ADDENDUM #1
INVITATION FOR BID #24-65

**NEWTON COMMONWEALTH GOLF COURSE MAINTENANCE FACILITY
IMPROVEMENTS AND RENOVATIONS**

Addendum to the Bidding Documents
Newton Commonwealth Golf Course
Maintenance Facility Improvements & Renovations

Addendum No. 1
April 19, 2024

1 FIRST FLOOR POWER PLAN
E2.0

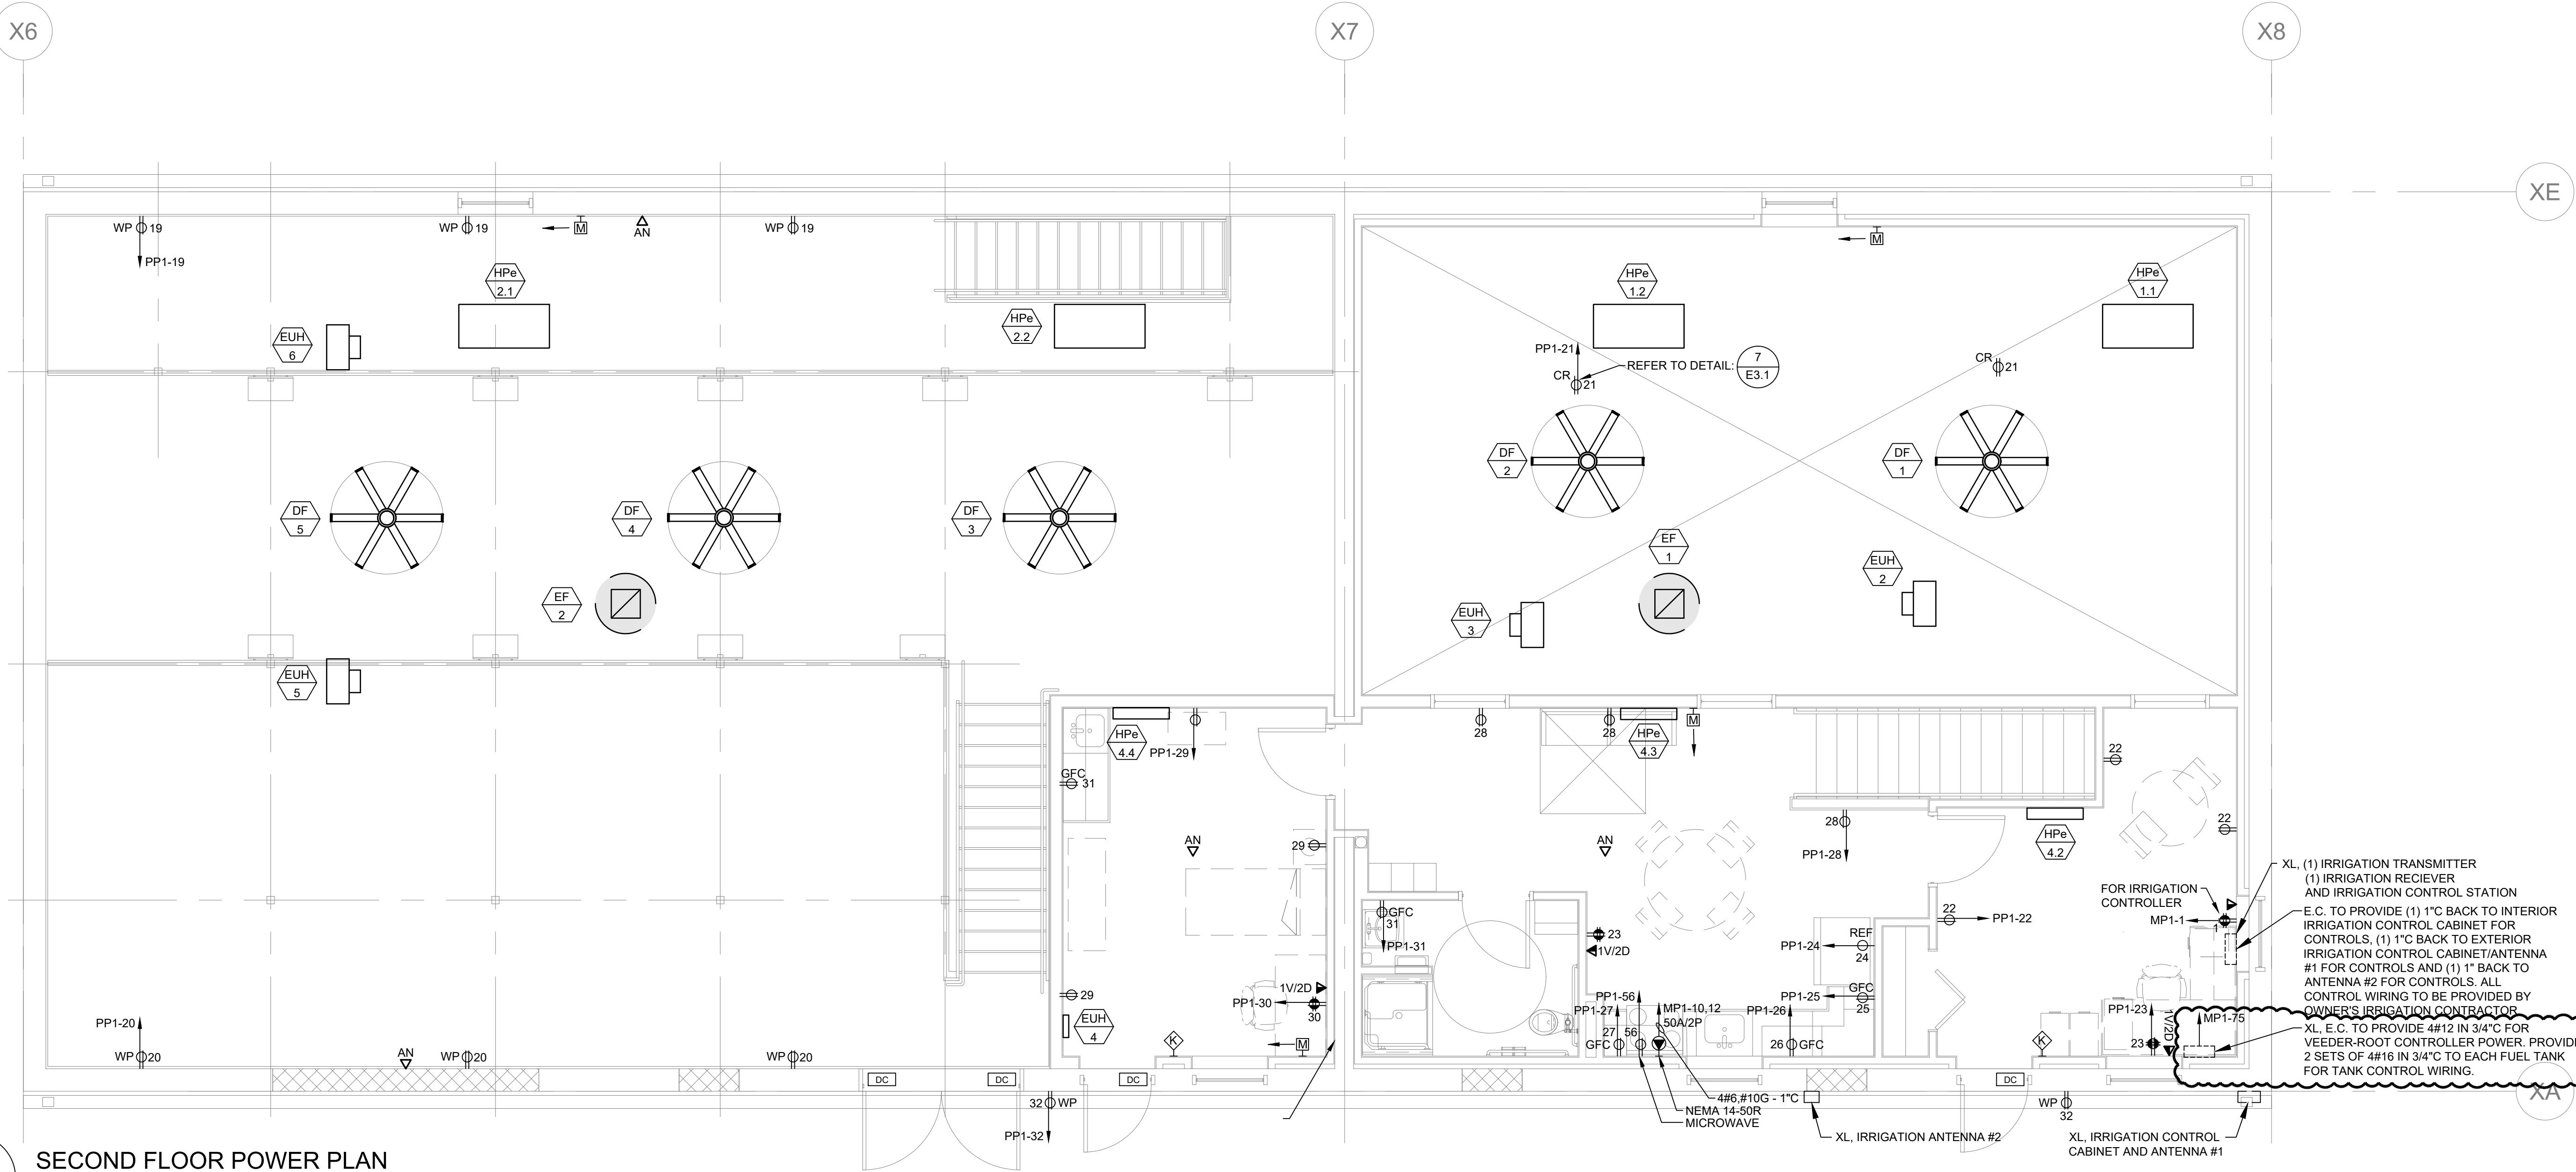
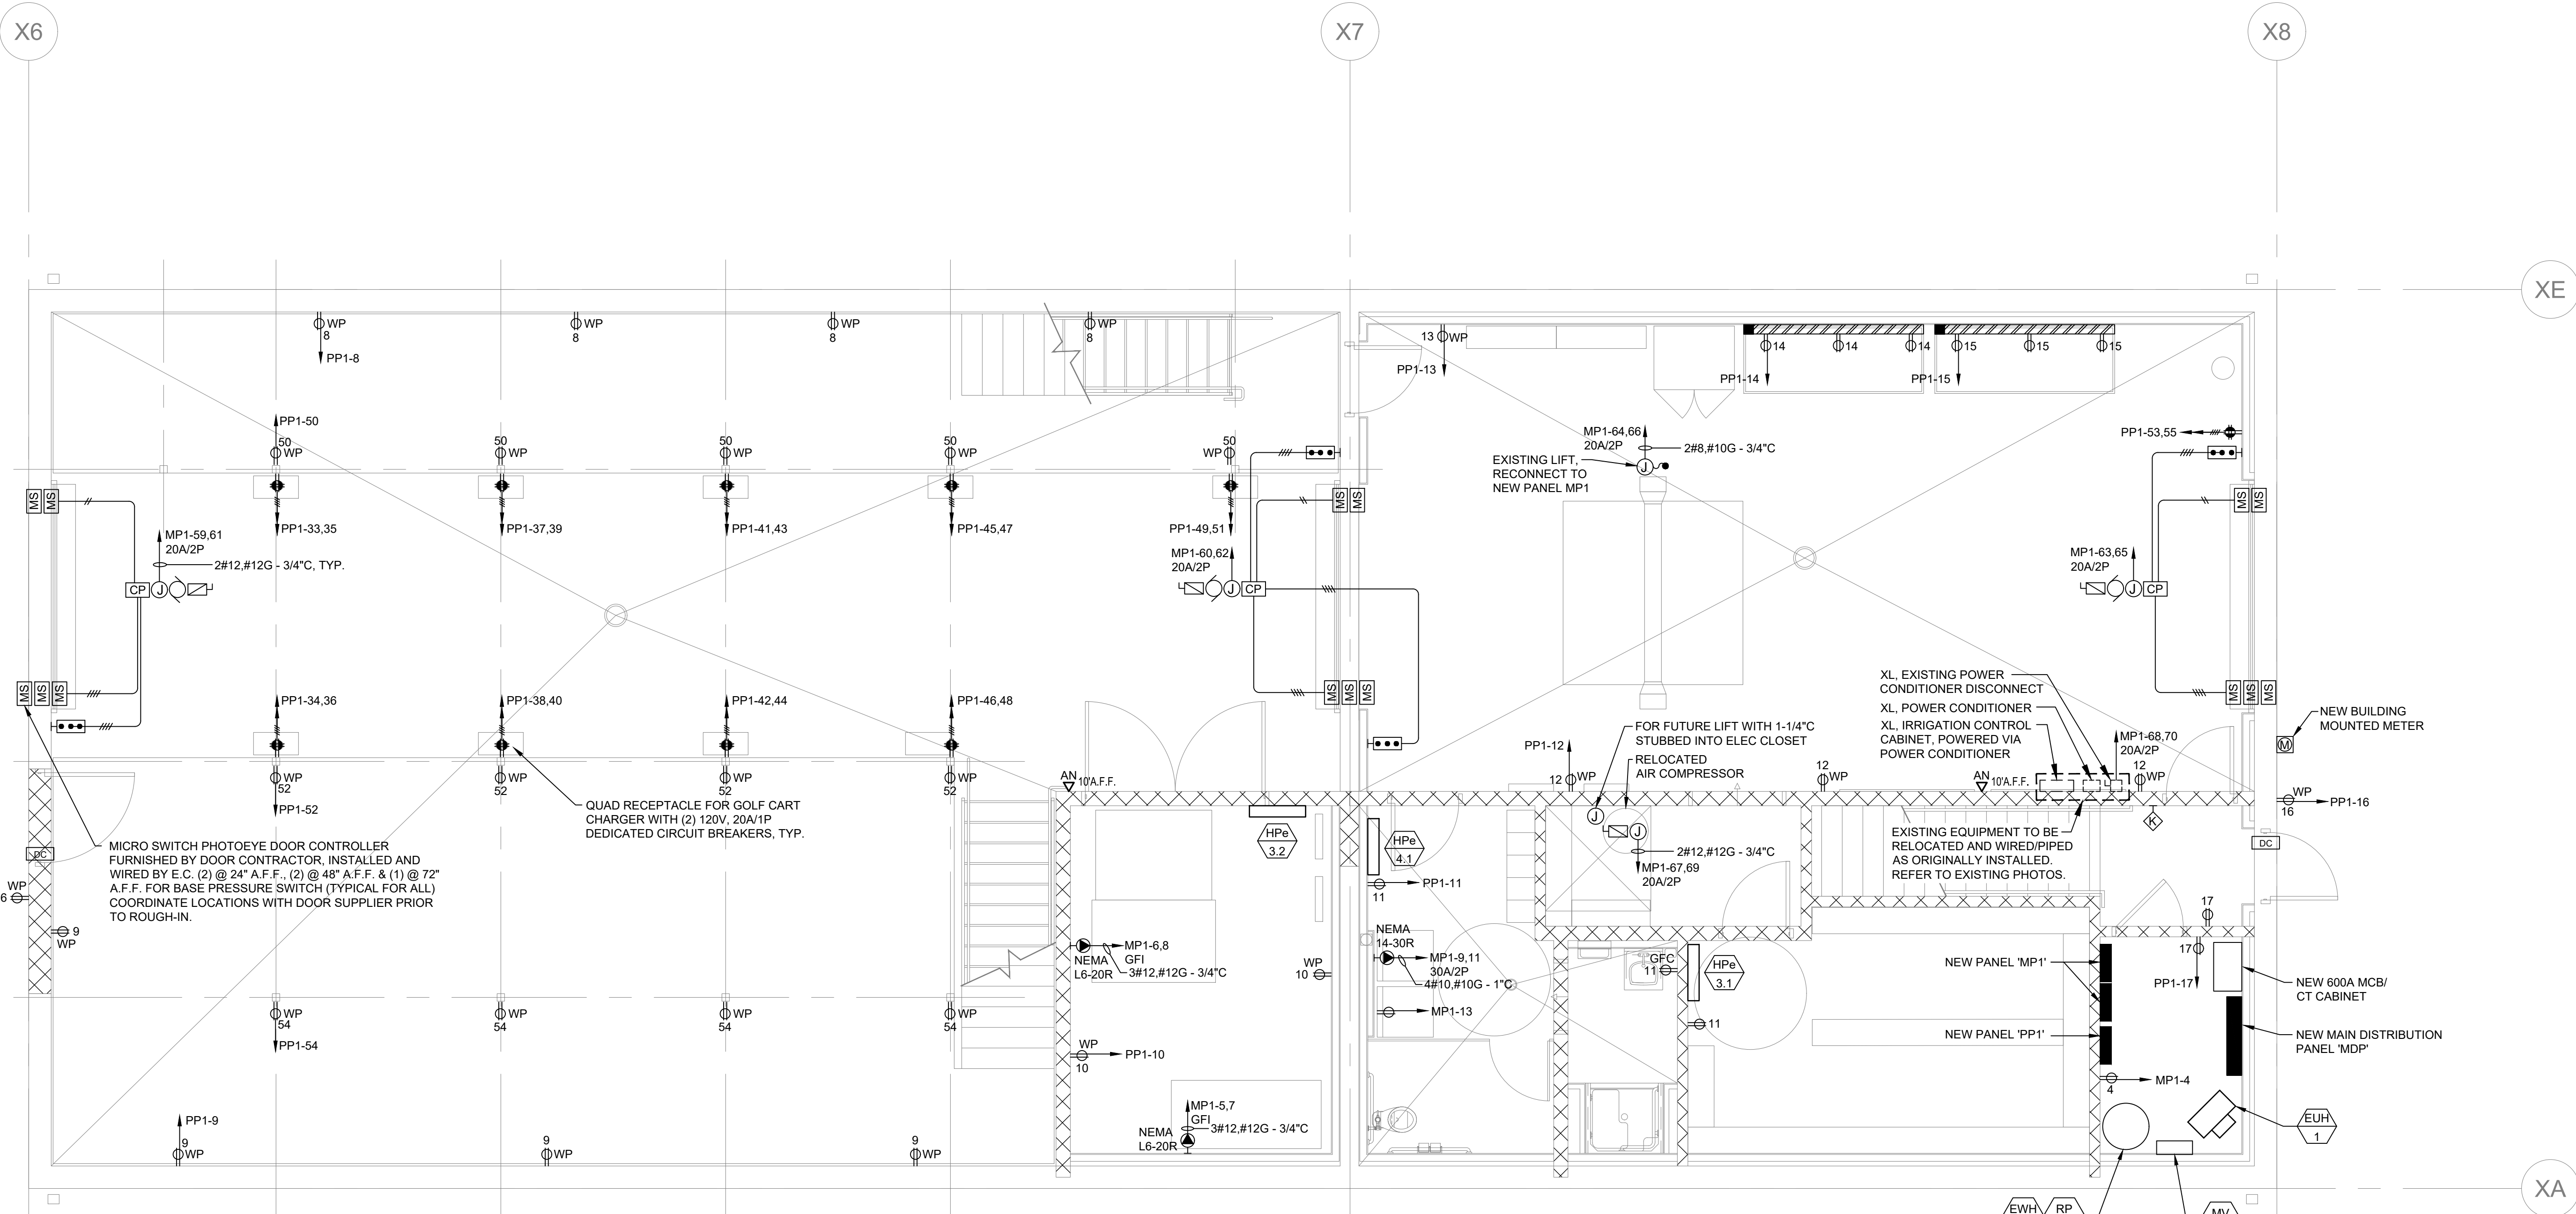
Item No. E-1.02 - Section 26 00 00 Electrical, paragraph 1.19: ADD sub paragraph D to read as follows: Electrical Contractor to provide 120V, 60A single phase feeder to owner provided storage unit utilizing temporary power, provided by the general contractor.
